Subject: Crystal River Unit 3
Docket No. 50-302
Operating License No. DPR-72

Technical Specification Change Request No. 39 (Appendix A)

Proposed Changes

These changes address the increase in Rated Thermal Power of Crystal River Unit 3 from 2452 MWt to 2544 MWt and the upcoming reactor refueling. This is supported in BAW-1521 "Crystal River Unit 3 - Cycle 2 Reload Report".

FIGURE 2.1-1
 REACTOR CORE SAFETY LIMIT

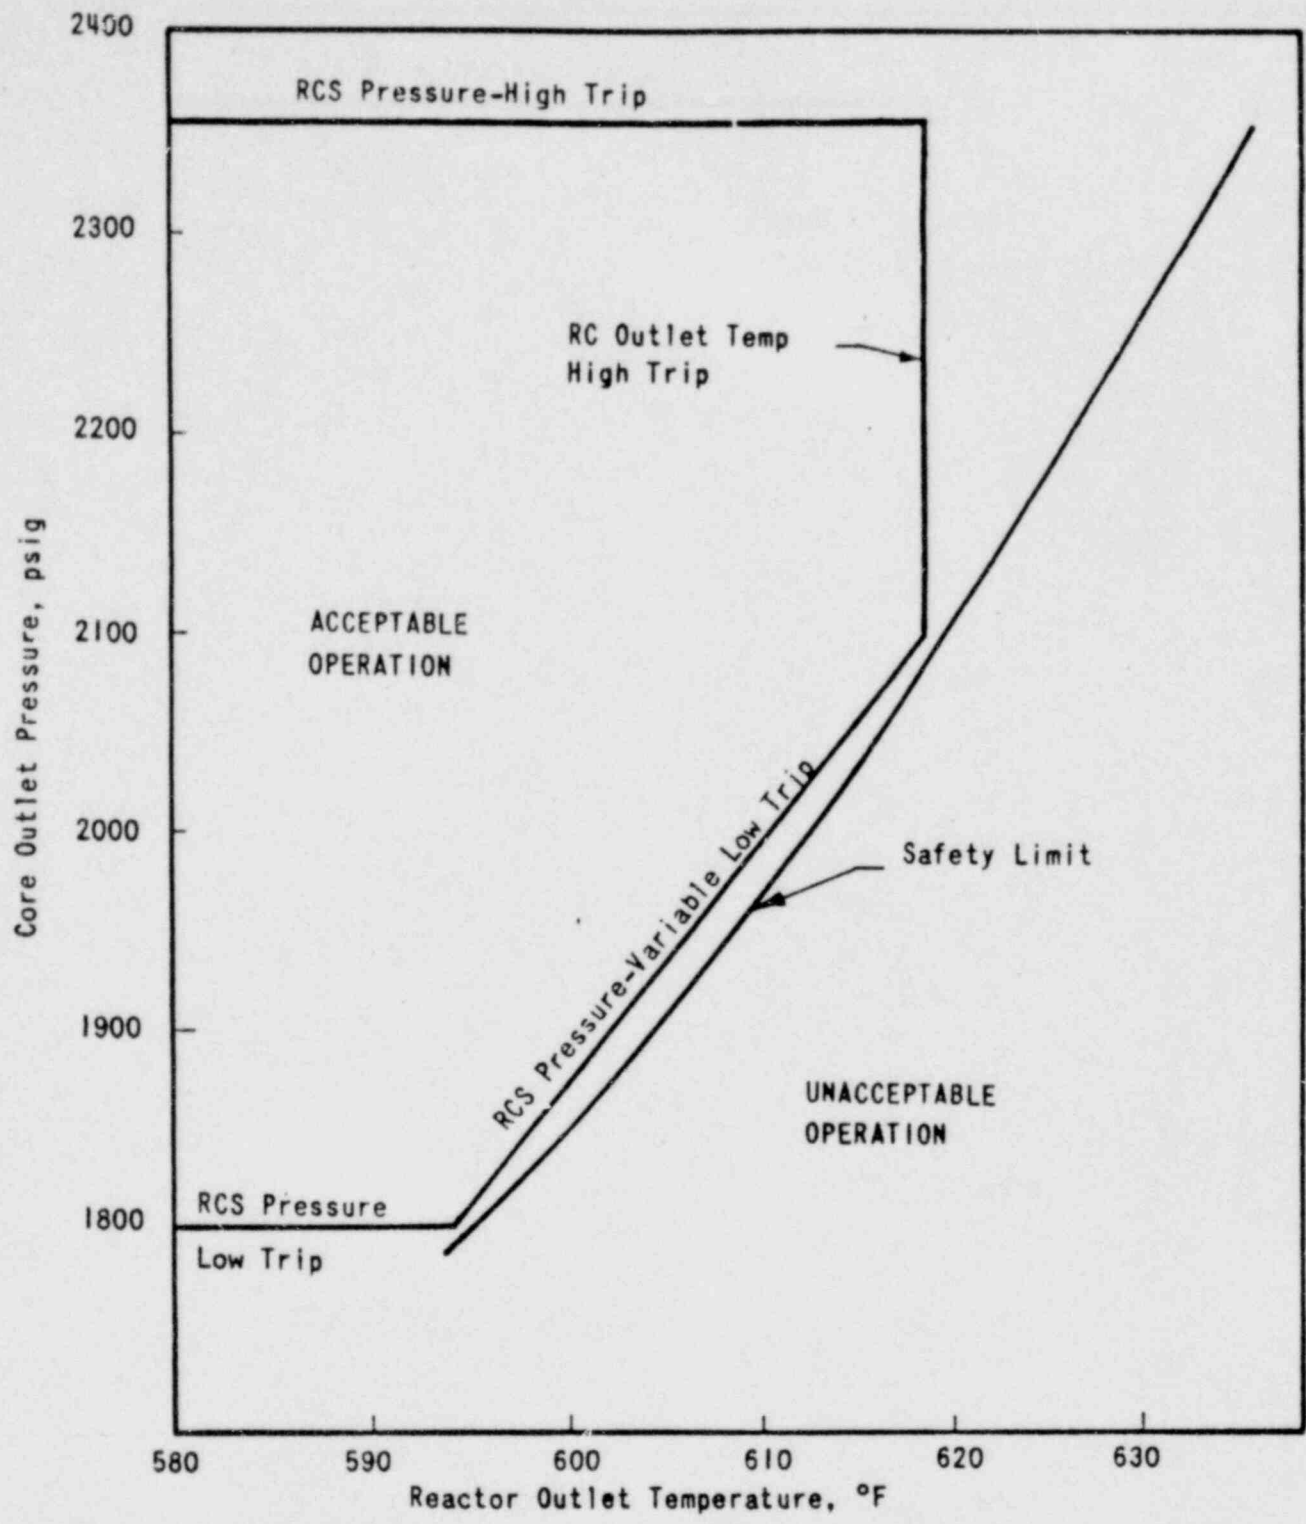
These changes include changing: 1) the Rated Thermal Power; 2) the Reactor Core Safety Limits and associated Bases; 3) the Limiting Safety System Settings and associated Bases; 4) the Regulating and Axial Power Shaping Rods insertion limits; 5) the control rod locations and group assignments; 6) the figures that specify the power level cutoff for Xenon Reactivity; 7) the Axial Power Imbalance Envelopes; 8) the Nuclear Heat Flux Hot Channel Factor and associated Bases; 9) the Quadrant Power Tilt Limits; and 10) the DNB Margin Limits.

The curve presented in Figure 2.1-1 represents the conditions at which a minimum DNBR of 1.30 is predicted for the maximum possible thermal power, 112%, when the reactor coolant flow is 139.6×10^6 lbs/hr, which is 106.5% of the design flow rate for four operating reactor coolant pumps. This curve is based on the following nuclear power peaking factors with potential fuel densification effects:

FIGURE 2.2-1

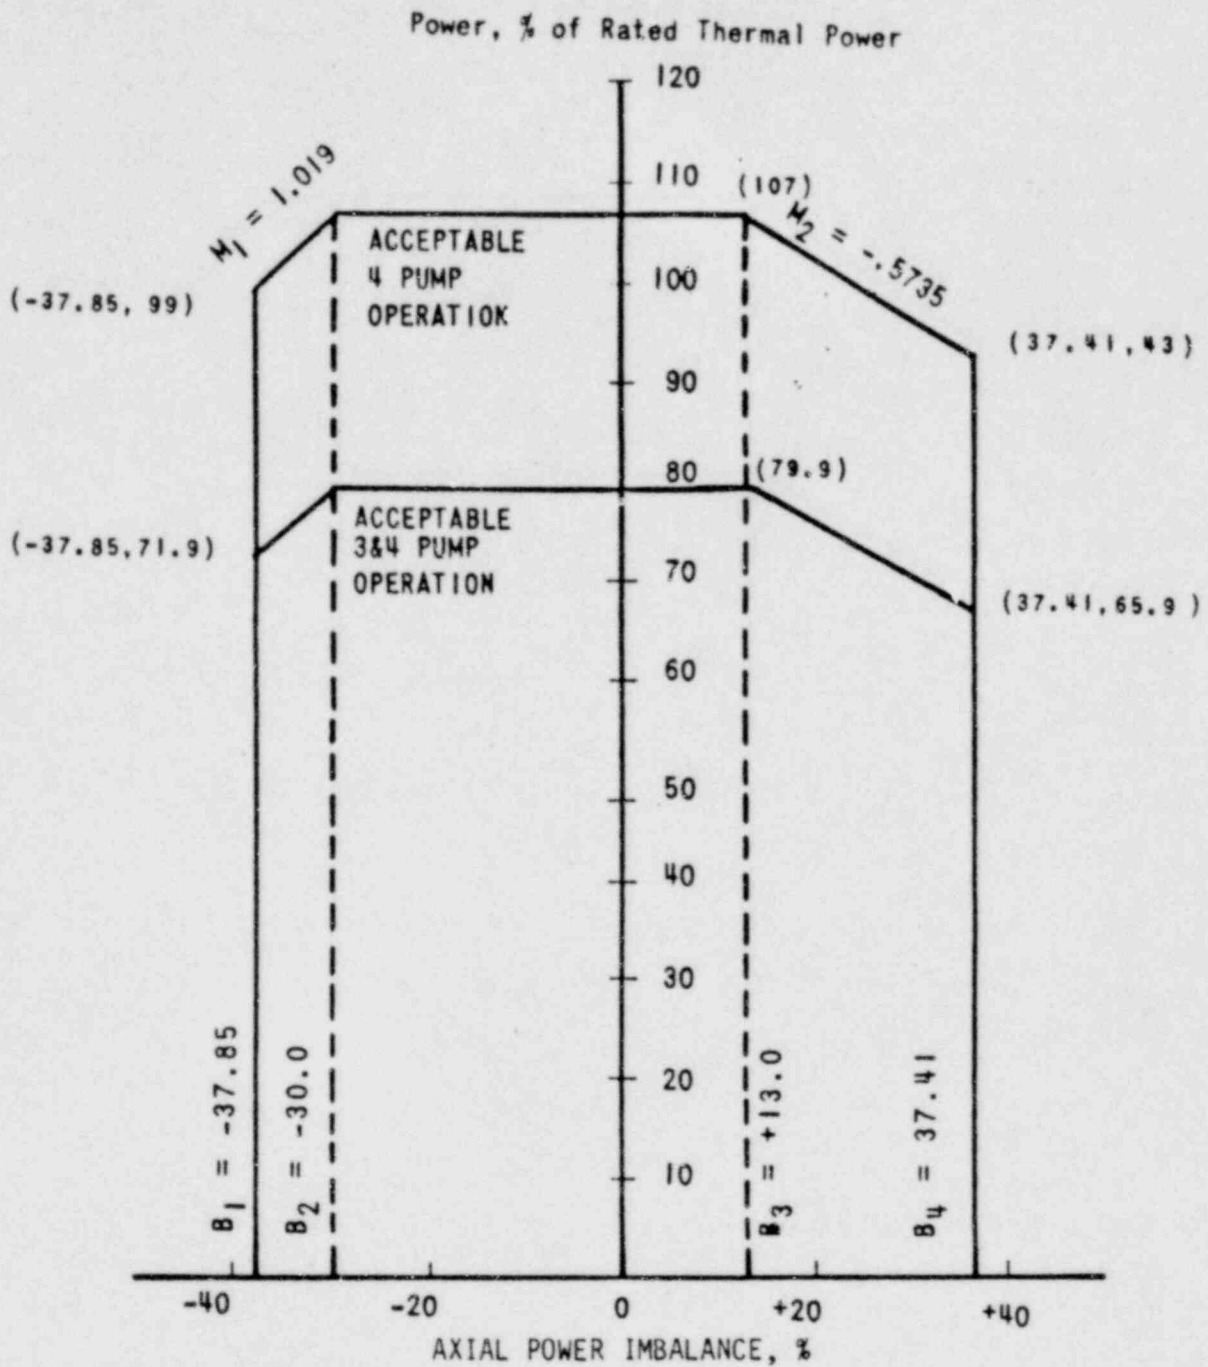
3. RCS Outlet Temperature-High	$\leq 619^\circ\text{F}$	$\leq 619^\circ\text{F}$
4. Nuclear Overpower Based on RCS Flow and AXIAL POWER IMBALANCE ⁽¹⁾	Trip Setpoint not to exceed the limit line of Figure 2.2-1	Allowable Values not to exceed the limit line of Figure 2.2-1

FIGURE 3.1-7
CONTROL ROD LOCATIONS AND GROUP ASSIGNMENTS

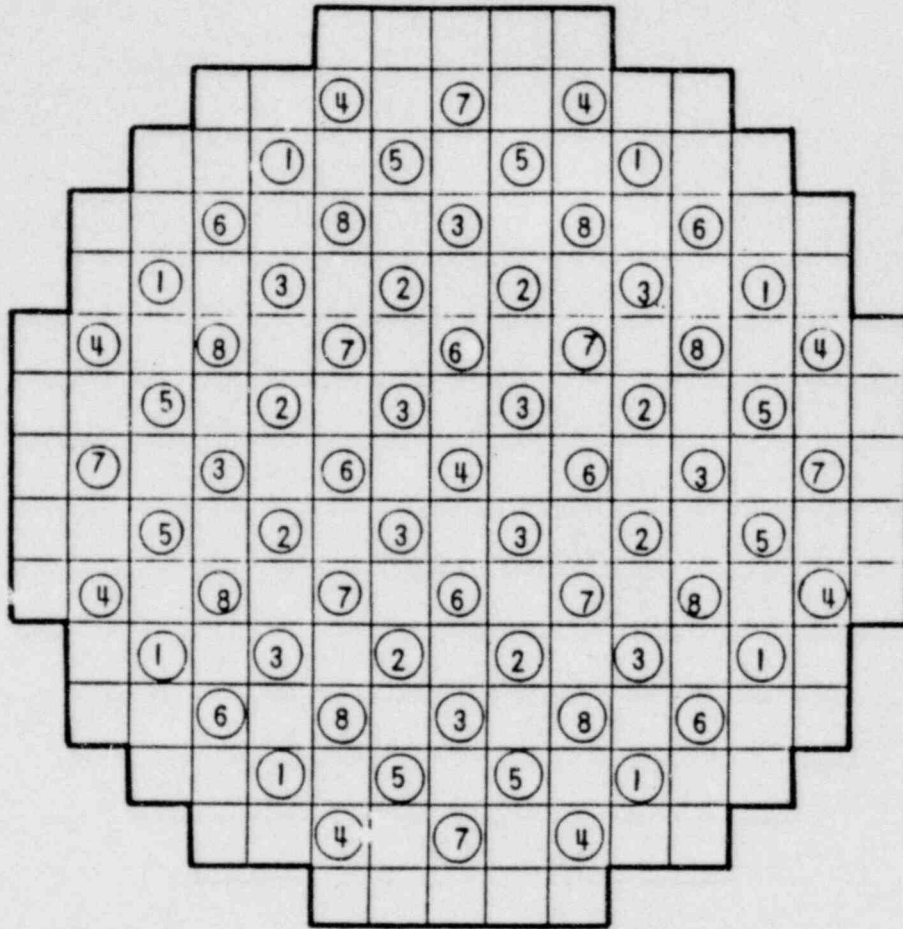
3.1.3.7 Each control rod (safety, regulating and APSR) shall be programmed to operate in the core position and rod group specified in Figure 3.1-7.

GROUP	NUMBER OF RODS	FUNCTION
1	8	SAFETY
2	8	SAFETY
3	12	SAFETY
4	9	SAFETY
5	8	CONTROL
6	8	CONTROL
7	8	CONTROL
8	8	APSRs
TOTAL	69

FIGURE 3.1-9

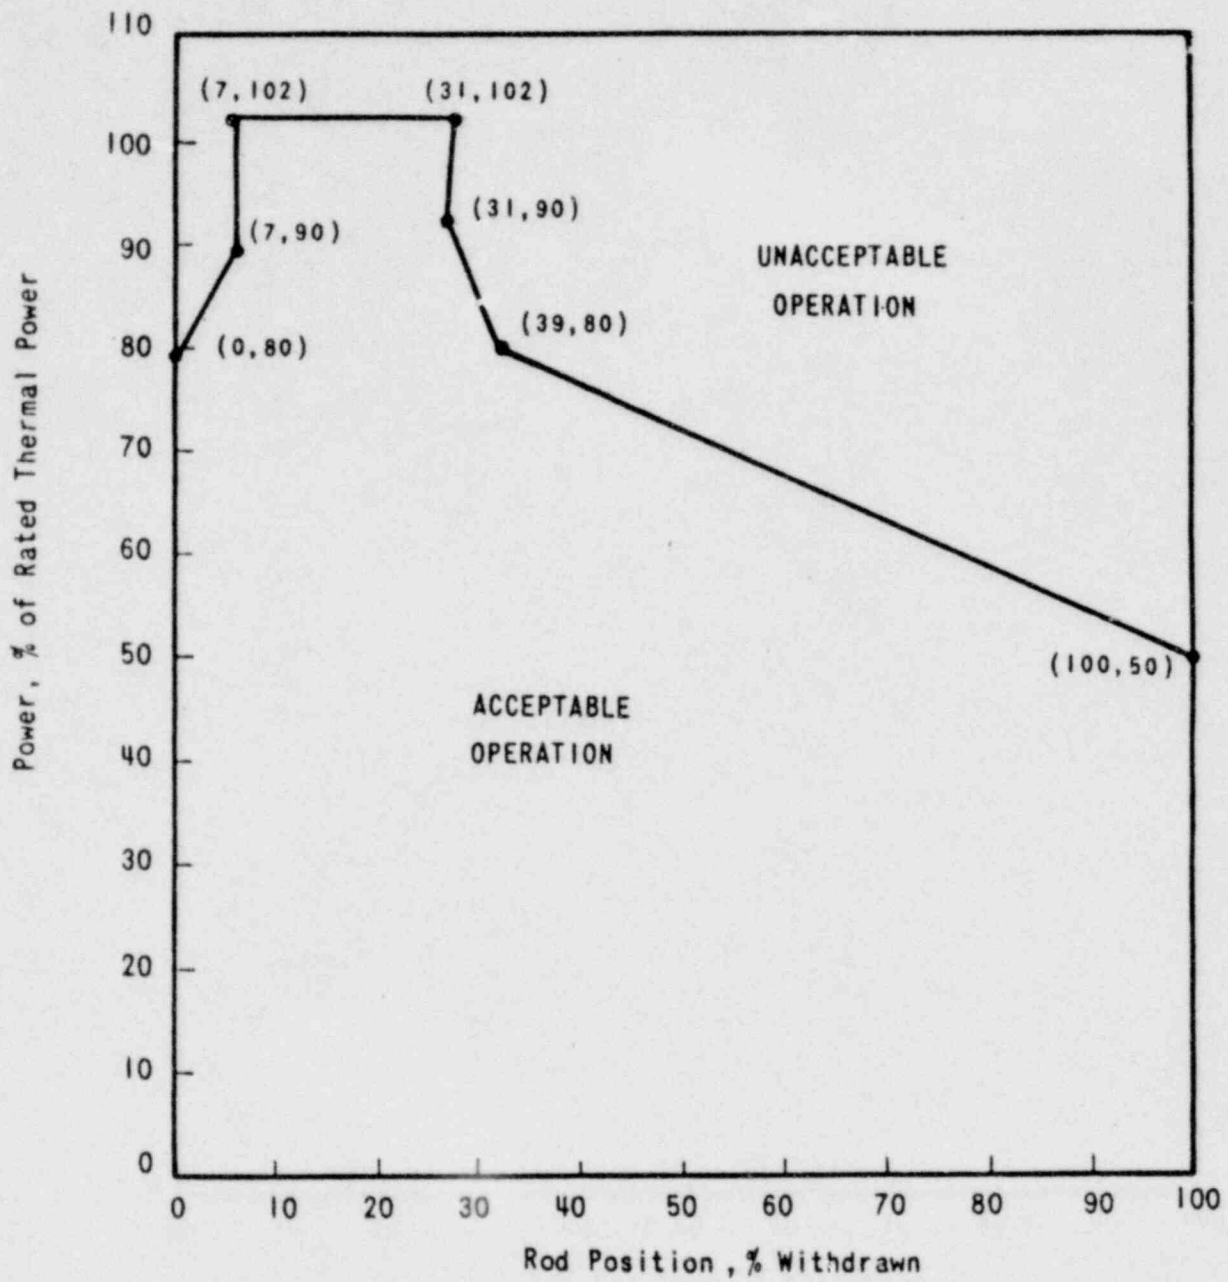
3.1.3.9 The axial power shaping rod group shall be limited in physical insertion as shown on Figures 3.1-9 and 3.1-10.

FIGURE 3.2-1

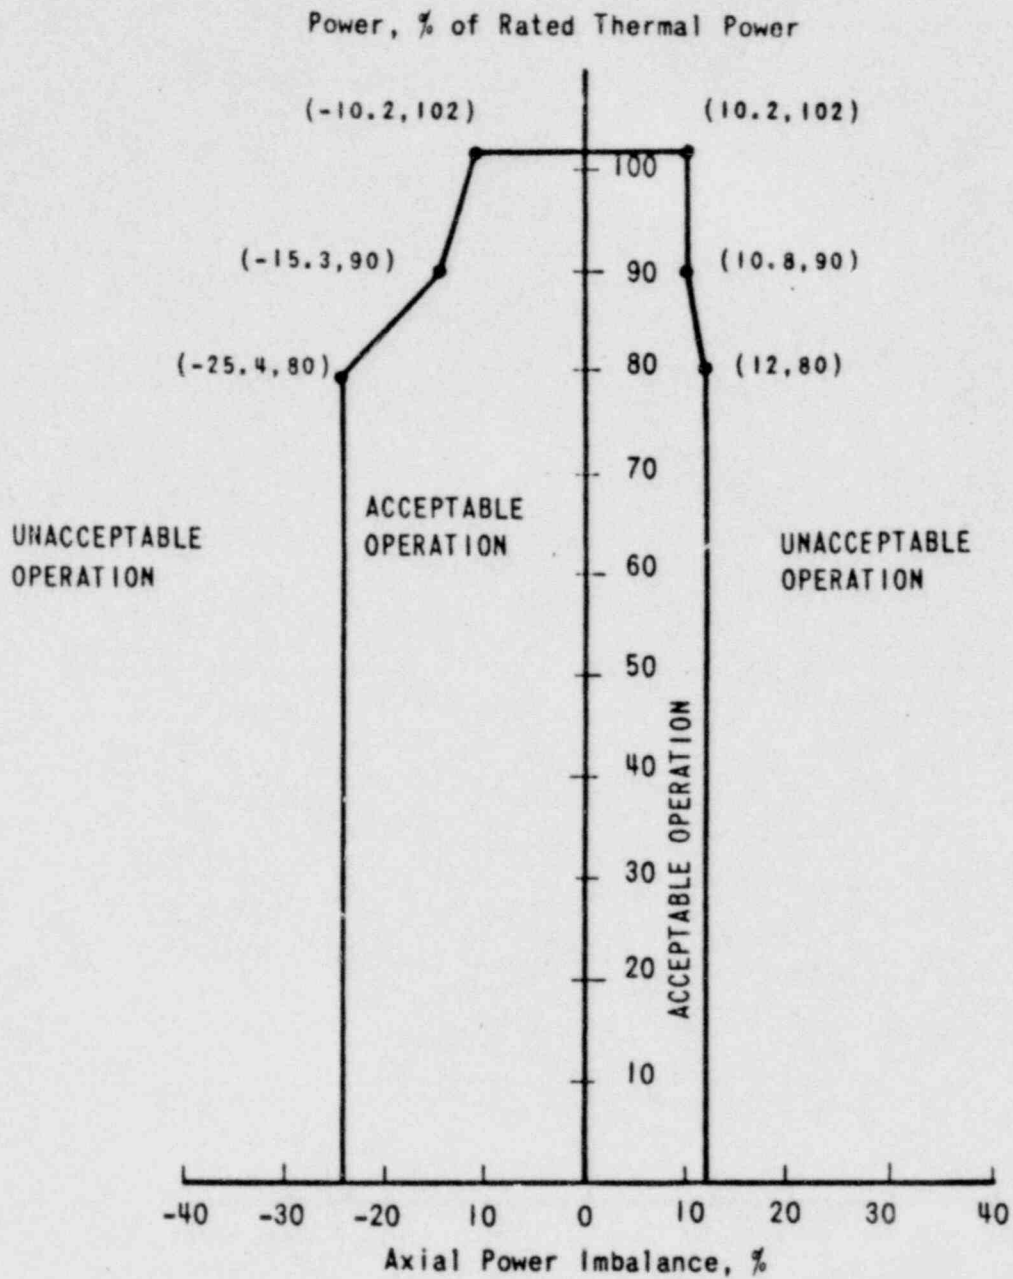
4. AXIAL POWER IMBALANCE limits are maintained. The AXIAL POWER IMBALANCE is a measure of the difference in power between the top and bottom halves of the core. Calculations of core average axial peaking factors for many plants and measurements from operating plants under a variety of operating conditions have been correlated with AXIAL POWER IMBALANCE. The correlation shows that the design power shape is not exceeded if the AXIAL POWER IMBALANCE is maintained within the limits of Figures 3.2-1 and 3.2-2.
